**Evaluation of HDR/SAWS
Modeling of the Carrizo-Wilcox Aquifer
in Lee, Bastrop, and Milam Counties, Texas**

George Rice
November 2001

Introduction

Comparison of Predicted Drawdowns Dutton Model and HDR Model

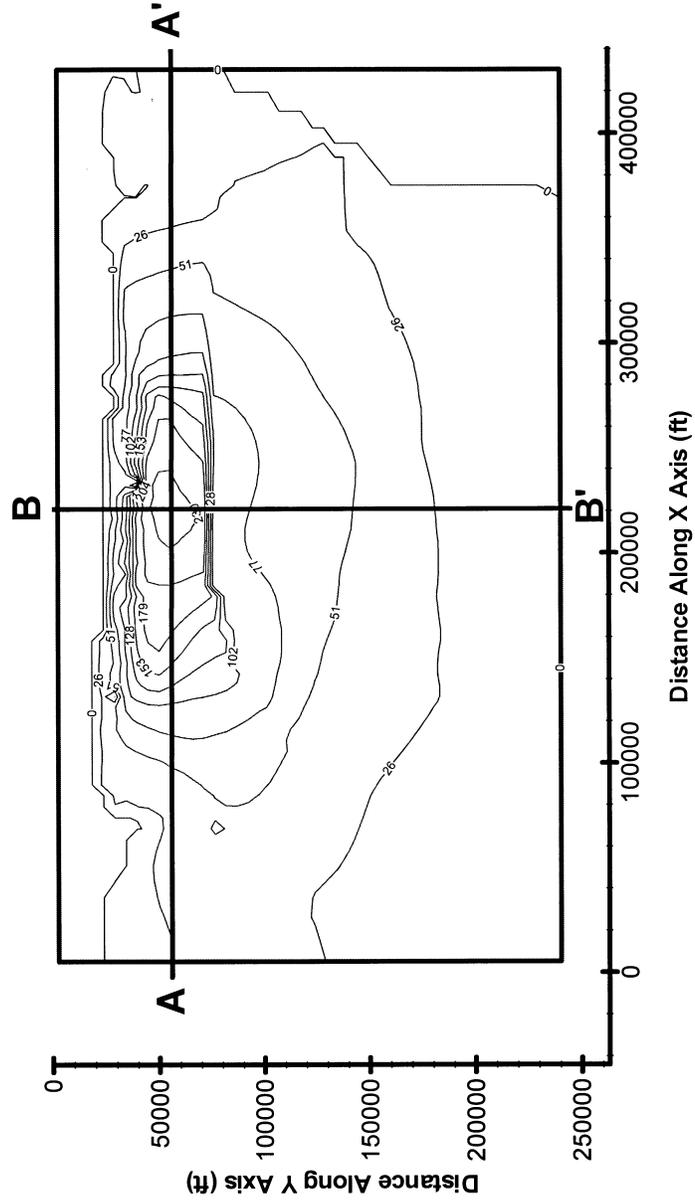
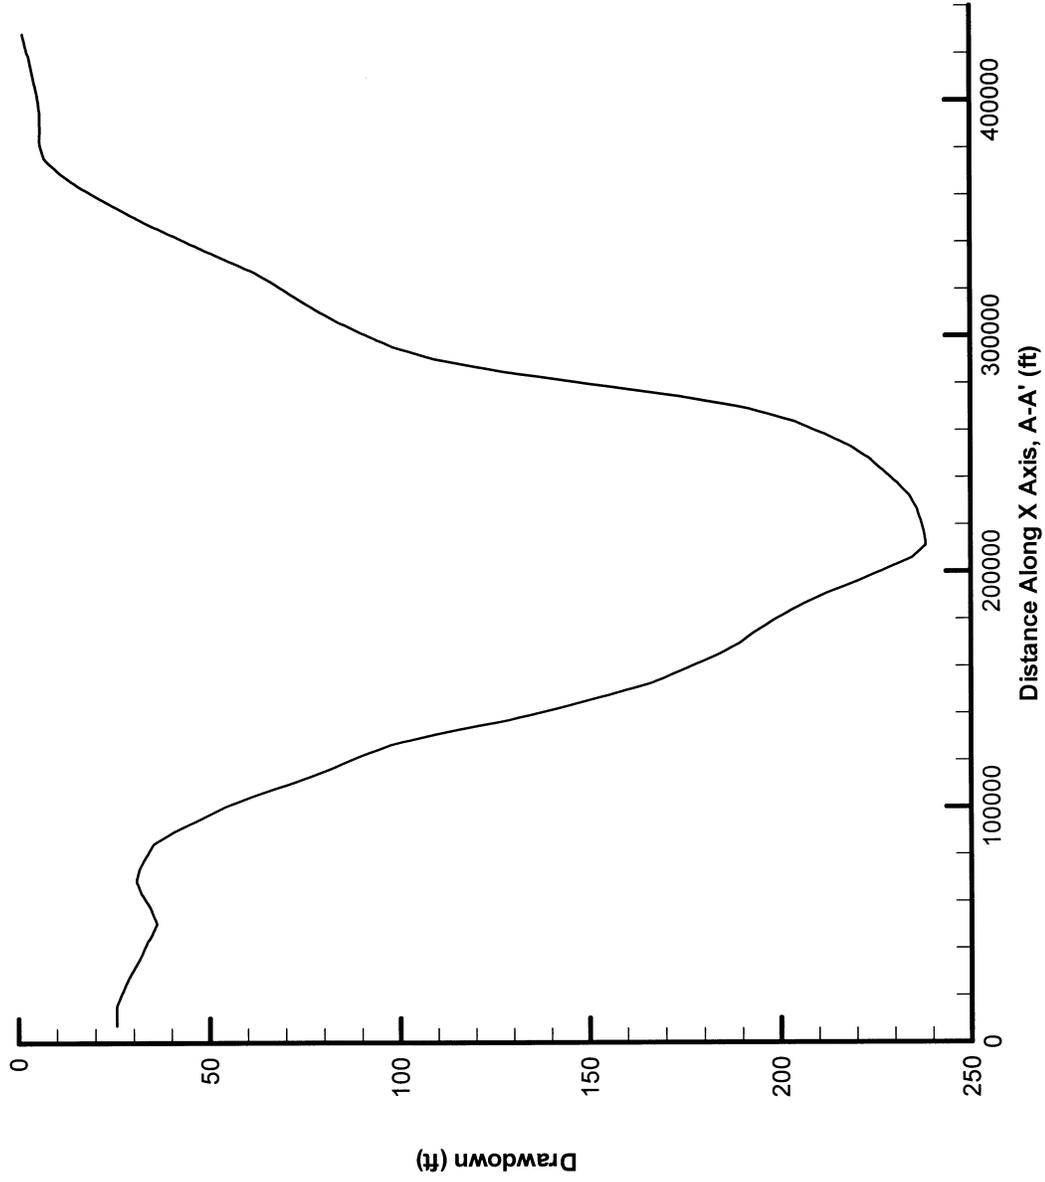
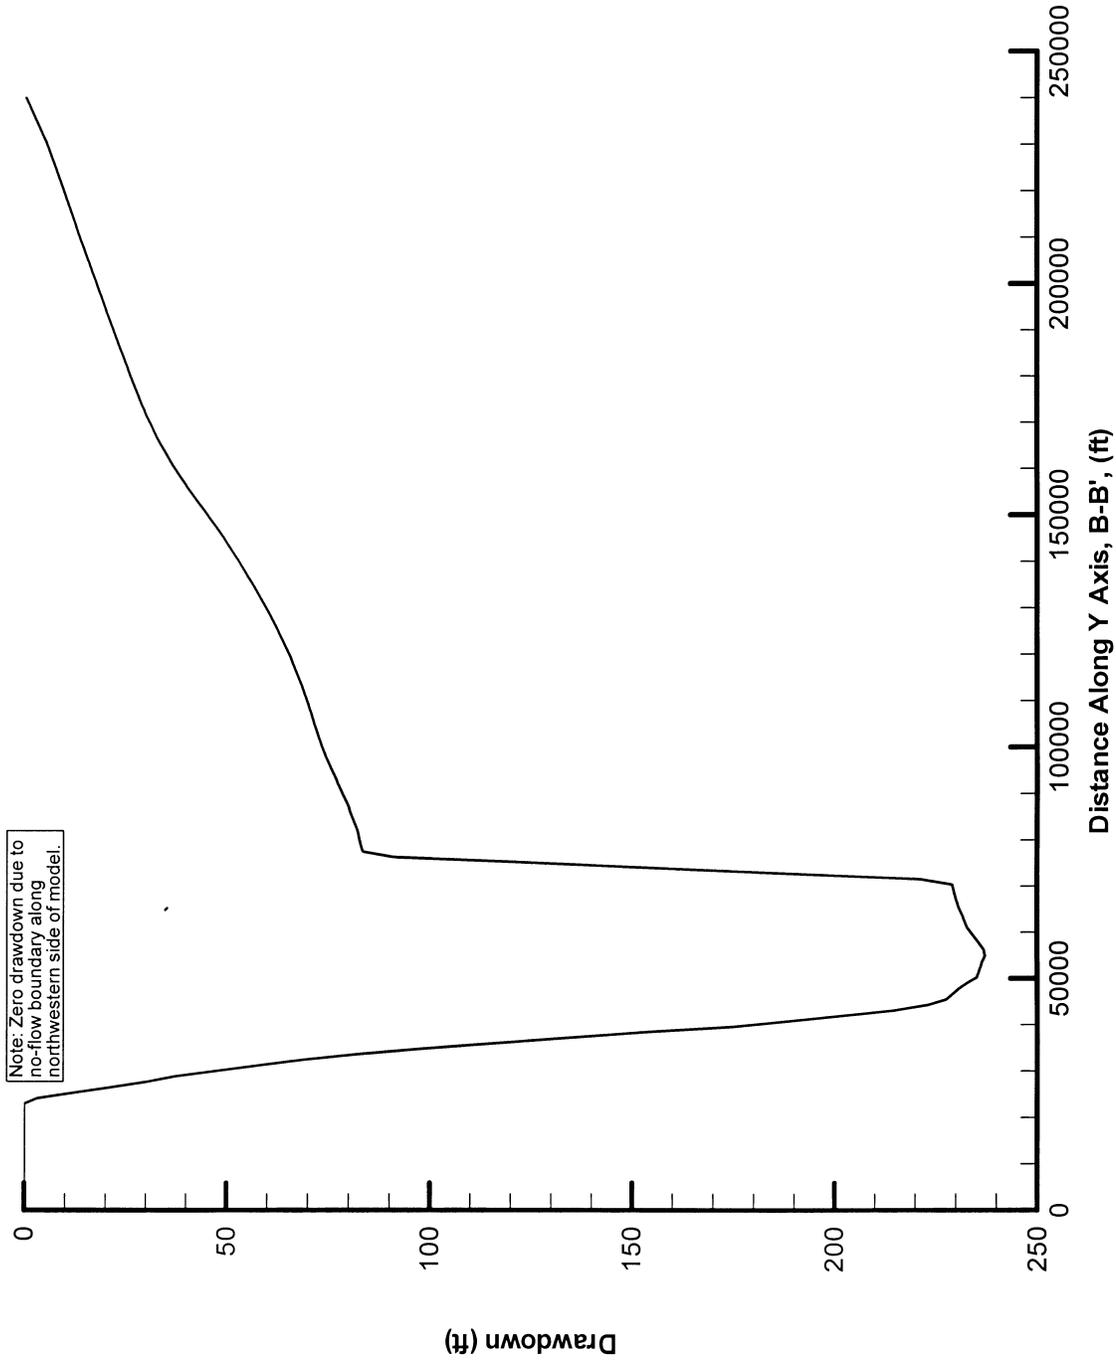
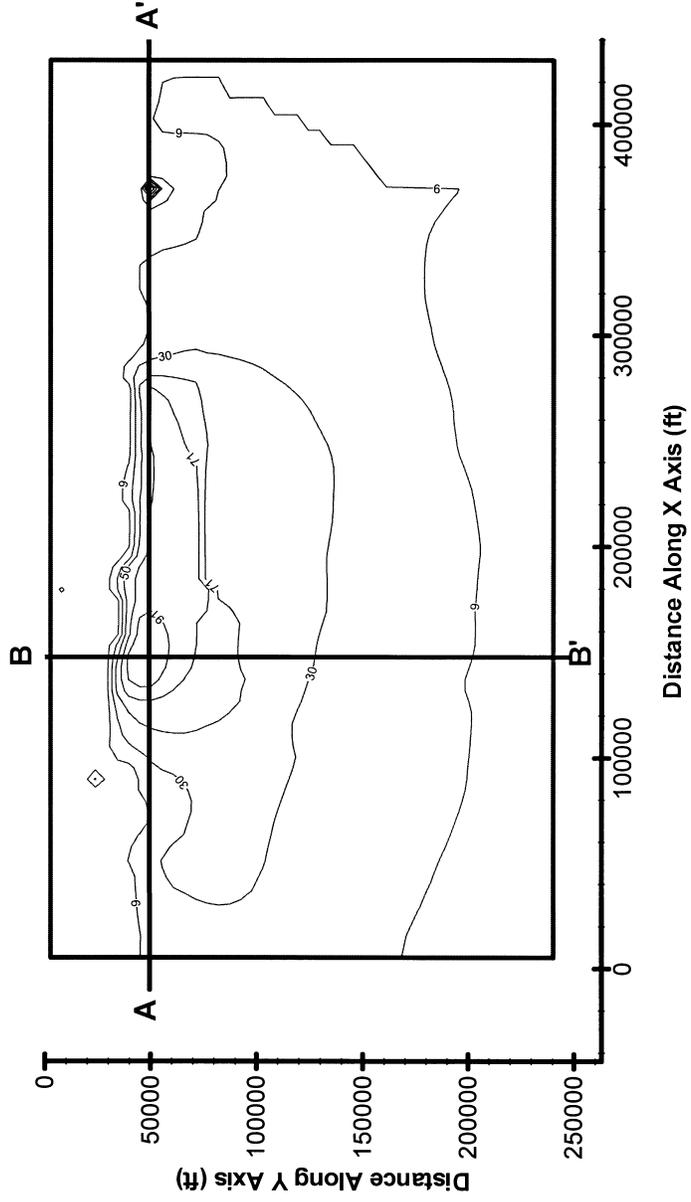
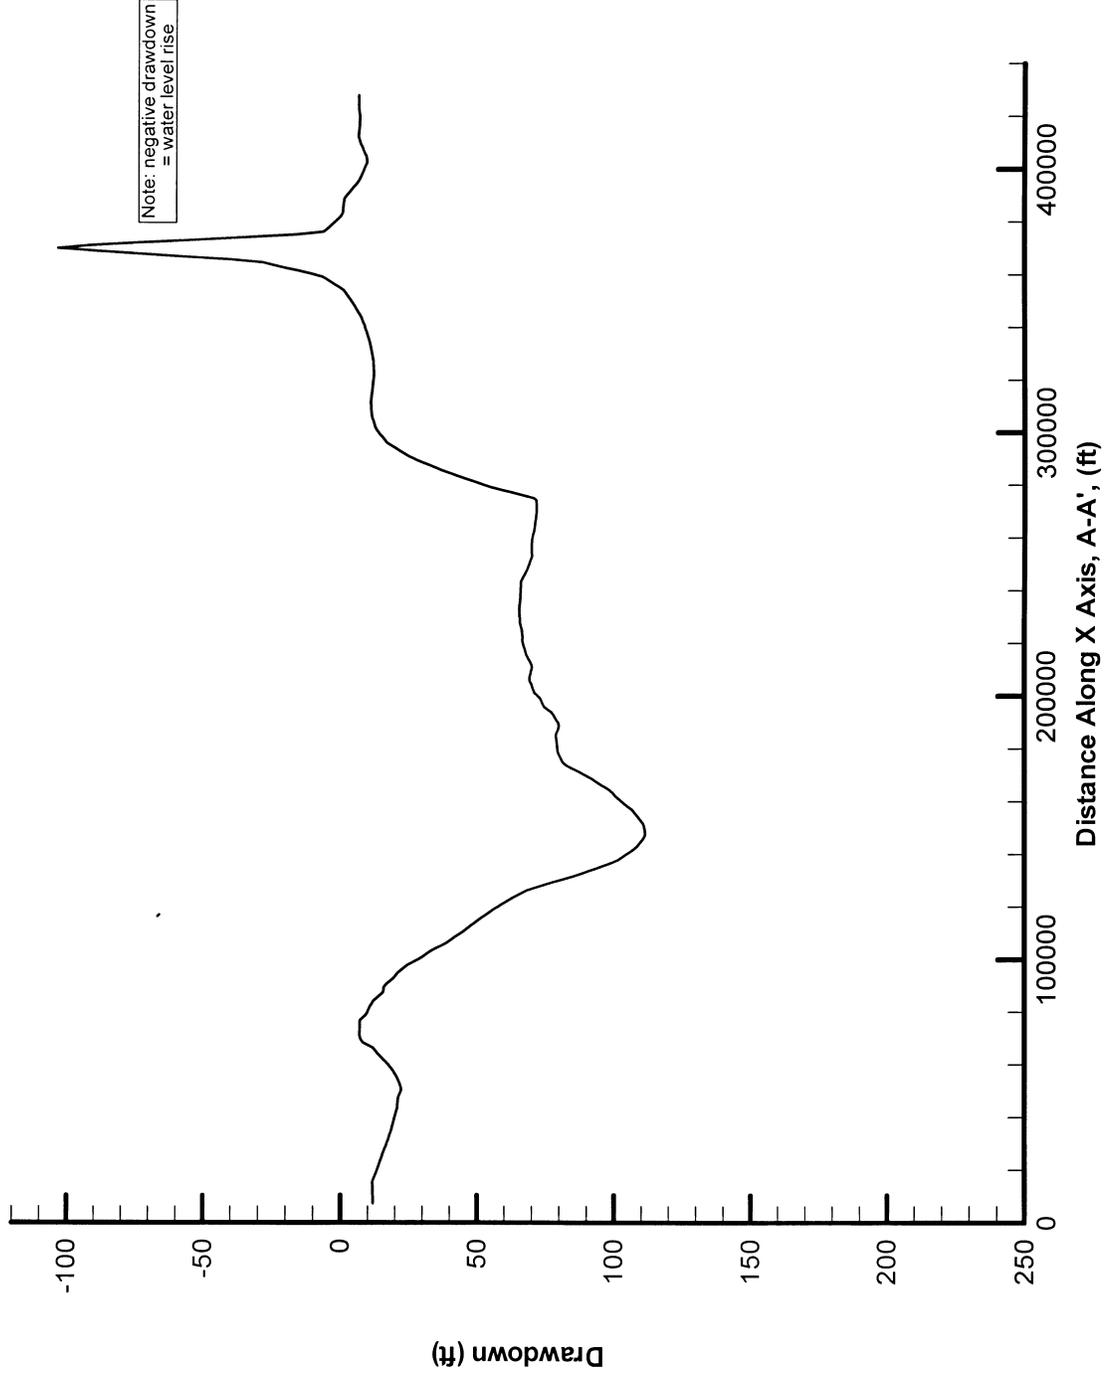
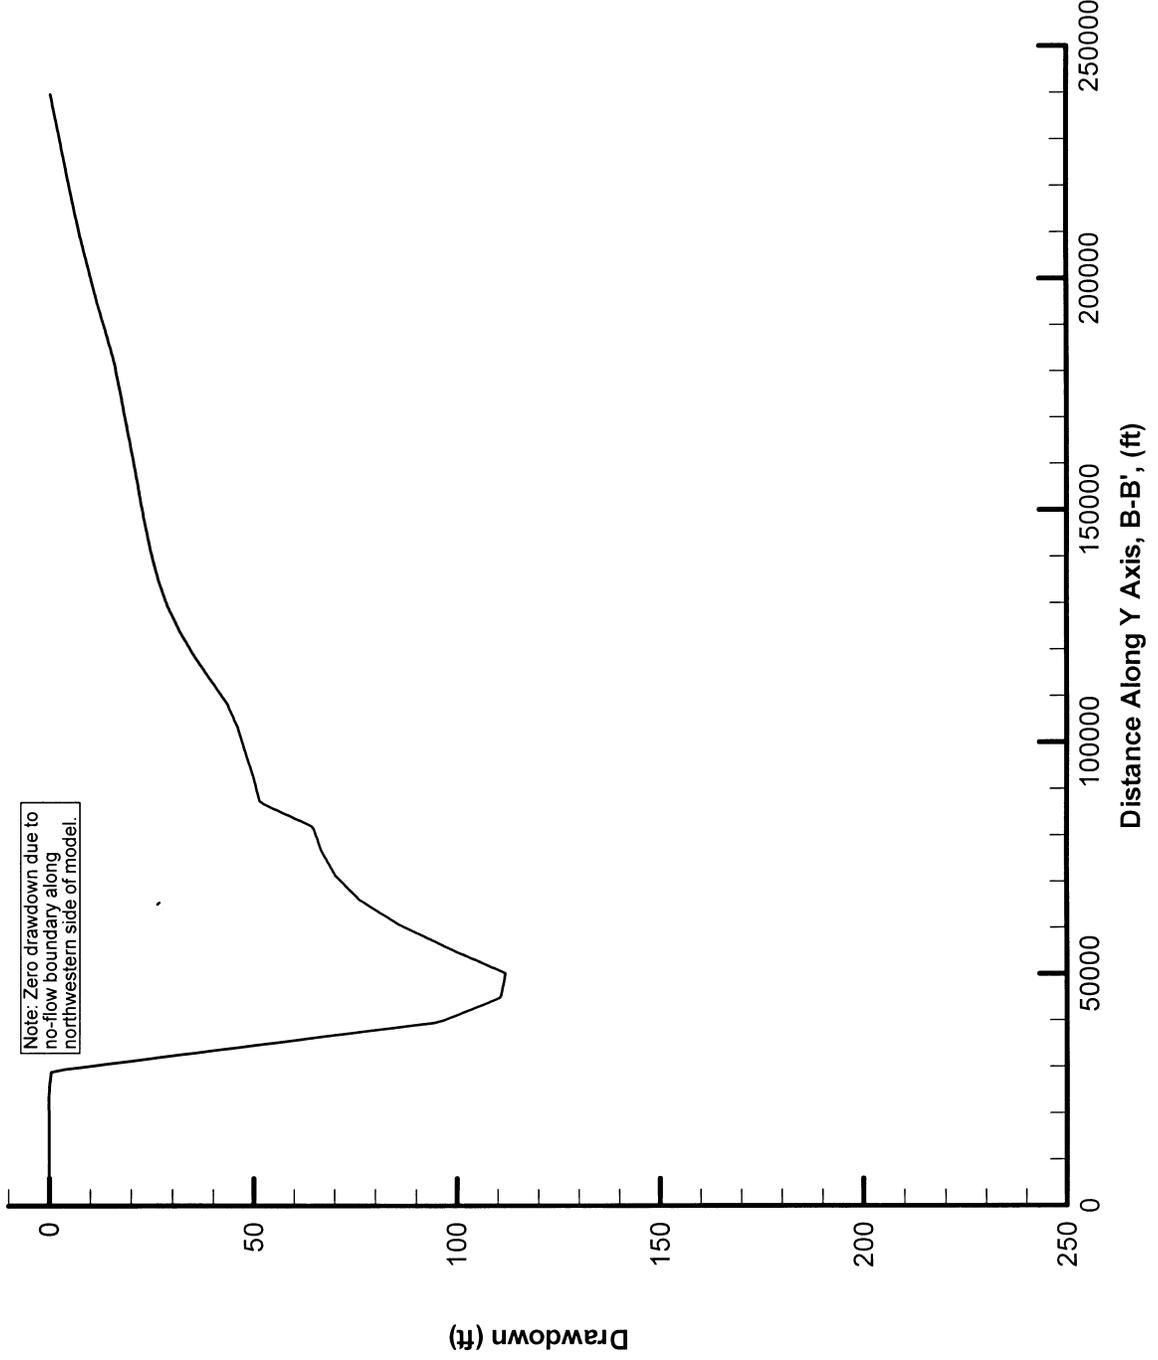
Dutton and HDR did not model identical withdrawal scenarios. Dutton predicted drawdowns for five withdrawal scenarios. The pumping rates ranged from approximately 49,000 ac-ft/yr to 258,000 ac-ft/yr¹⁶. HDR predicted drawdowns for two withdrawal scenarios with pumping rates of 55,000 ac-ft/yr and 75,000 ac-ft/yr. In order to compare like scenarios, the pumpage scheme in Dutton's model was replaced by HDR's 55,000 ac-ft/year pumpage scheme. That is, the well locations, pumping rates, and pumping schedules in the Dutton model were removed and replaced with those from the HDR model. No other changes were made to the Dutton model input.

Figures A-1 through A-3 illustrate drawdowns predicted for the year 2040 by the Dutton model with the HDR pumpage scheme. Figures A-4 through A-6 illustrate drawdowns predicted for the year 2040 by the HDR model. The HDR model predicts significantly lower drawdowns than the Dutton model. The maximum drawdown predicted by the HDR model for the year 2040 is 112 feet. The maximum drawdown predicted by the Dutton model for the year 2040 is 239 feet.

In figures A-1 and A-4, the top and bottom of the drawdown plot correspond to the northwest and southeast boundaries of the study area, respectively (see figure 1). The left and right sides of the plots correspond to the southwest and northeast boundaries. The cross sections A-A' and B-B' pass through the area of greatest drawdown predicted by each model. The area of greatest drawdown predicted by the HDR model is approximately 12 miles southwest of the area of greatest drawdown predicted by the Dutton model.
